# AUI-C2C TBD Removal

Comments 548-551, 553-556

H. Heck, TE Connectivity  
2025.01.21

Provide proposed value for all Annex 176C TBDs in D1.3.

Figure 176C-6—Channel insertion loss limit

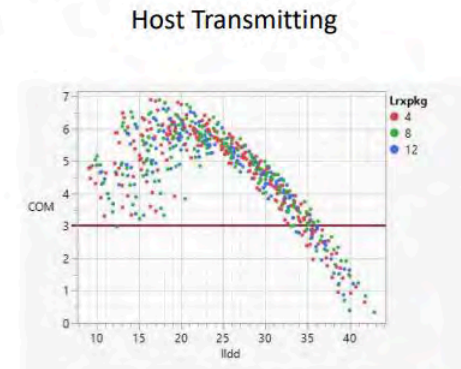
- Channel ILdd is TBD in Table 176C-5 and in 176C.5.2.
- 176C.5.2 also has a TBD frequency mask equation and plot.

The channel insertion loss should meet Equation (176C-4). Actual channel insertion loss could be higher or lower than that given by Equation (176C-4) due to the channel insertion loss deviation (ILD), return loss, and crosstalk. Note that for this equation the channel insertion loss at the Nyquist frequency is less than or equal to TBD dB.

- Set recommended channel insertion loss = 32 dB in Table 176-5 and in 176C.5.2.
  - Based on slide 7 of heck\_3dj\_01a\_2407.
  - Comment #254 proposes the same value.
- Remove equation (176C-4) and Figure 176C-6.
  - Consistent with 178.10.3.
  - Comment #449 also proposes to delete the equation and figure.

**176C.5.2 Channel insertion loss (recommended)**  
The recommended channel insertion loss, I<sub>l</sub>dd, is 32 dB at 53.125 GHz.
